# **Generic Environmental Impact Statement for License Renewal of Nuclear Plants**

**Supplement 27**

**Regarding  
Palisades Nuclear Plant**

**Final Report**

Figure 2-3. Palisades Site Layout

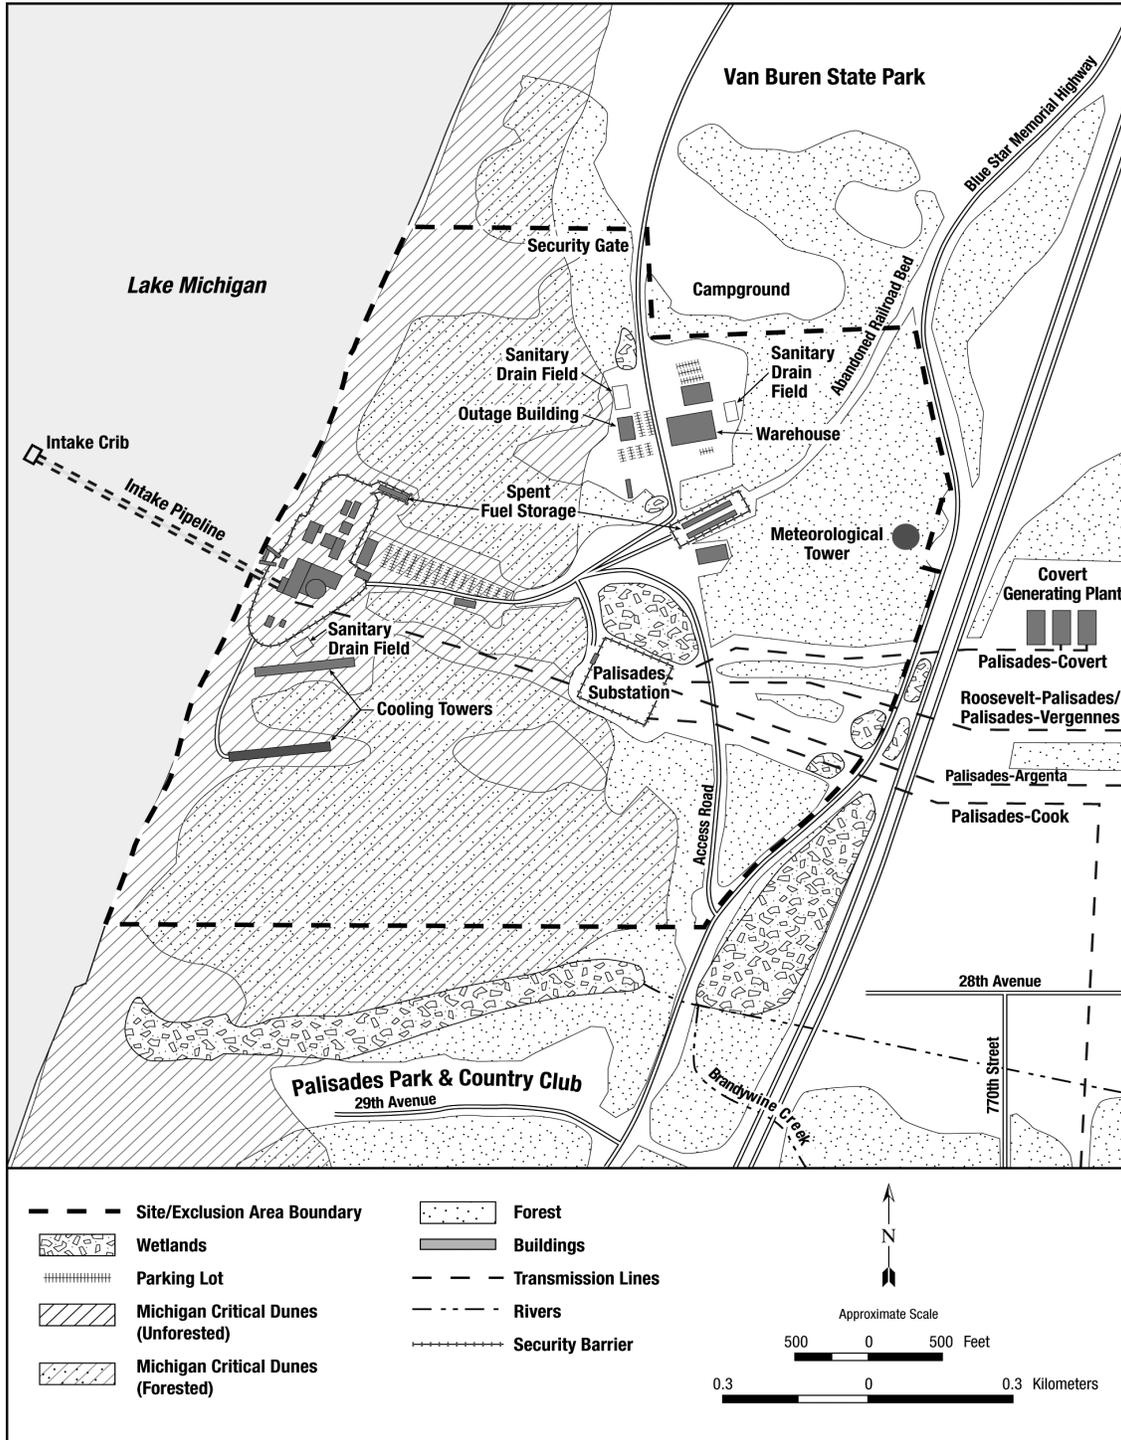
**Comment:** Page Number 2-14, Line Number 39-40. Change to “Sanitary waste is sent to three onsite septic systems.” (See DSEIS Figure 2-3). (OO-5)

**Comment:** Page Number 8-4, Line Number 29. Palisades has three onsite sanitary drain fields (see DSEIS Figure 2-3). (OO-50)

**Figure 4-1.** Geographic Distribution of Minority Populations (shown in shaded areas) Within 50 mi of Palisades Based on Census Block Group Data

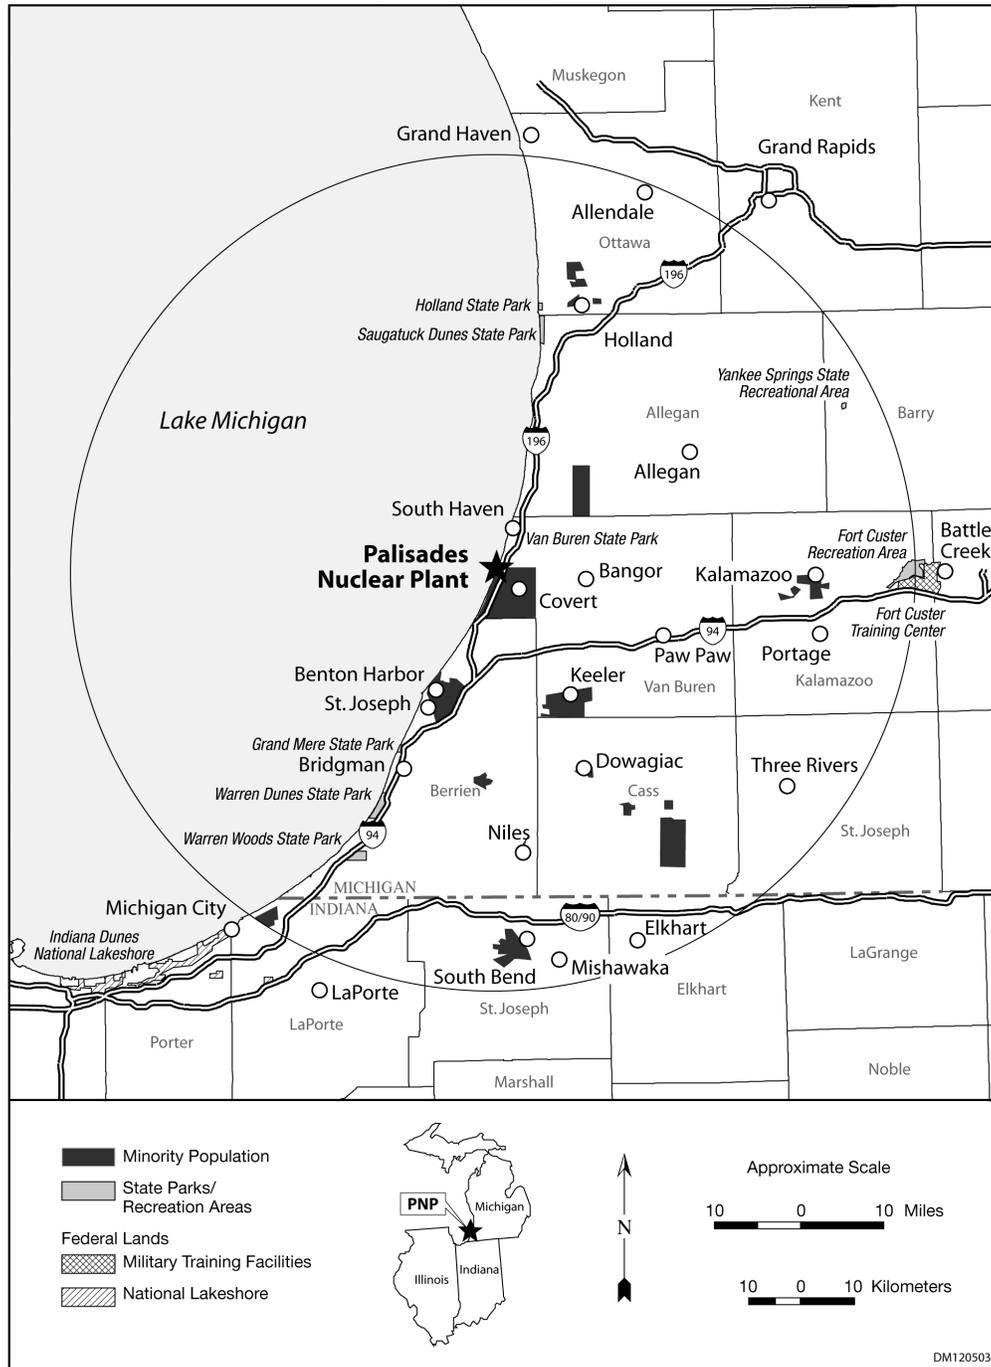
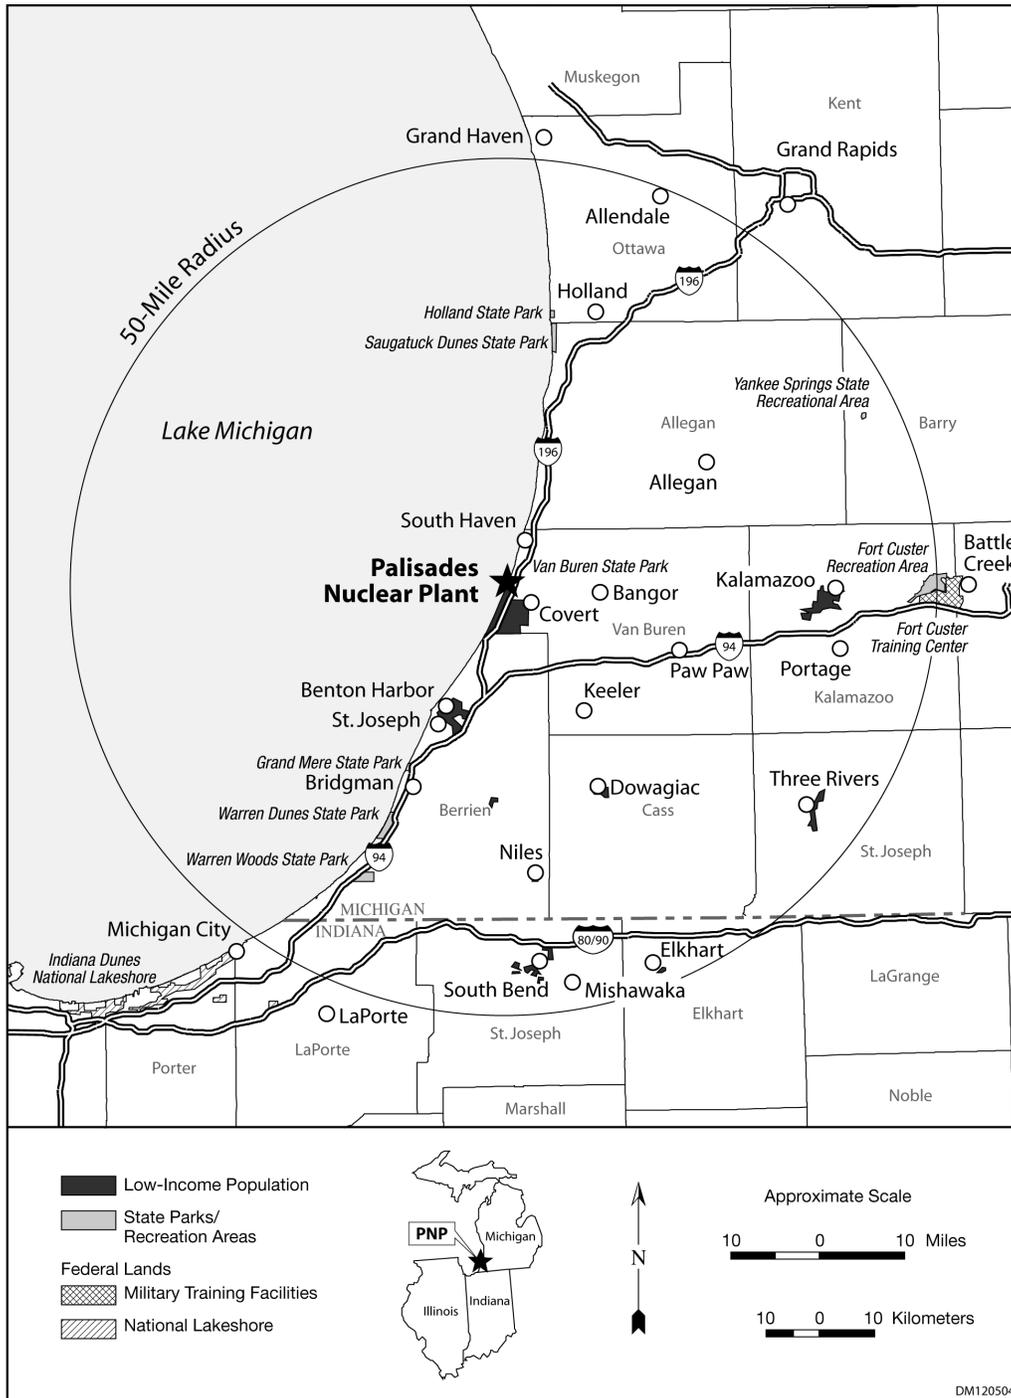
**Comment:** It is baffling NRC concludes that "offsite impacts from Palisades on minority and low-income populations would be SMALL (sic), and no special mitigation actions are warranted." (EIS, p. 4-31) Just three pages earlier, NRC admits that "[c]ensus block groups with a minority population . . . are located in Covert," Palisades' hometown. Figure 4-2 on p. 4-30 also identifies Covert's predominantly African American population as low-income." Why Covert's African American community is still low-income after 38 years of substantial profit-making at Palisades is quite troubling. In addition, Covert's community suffers the worst radiation doses from routine operations at Palisades, and would suffer the worst health impacts from accidental radiation releases. NRC even ignores the fact that Palisades' tax contributions to its neighboring community in Covert are dwindling over time - shown in Nuclear Management Company's 2005 Environmental Report -- so residents suffer worsening risks as the reactor deteriorates with age, while also receiving decreasing benefits such as tax income. (see <http://www.astrongerkinship.com/> for a recent book about the African American history of Covert). (MM-8) (NN-8)
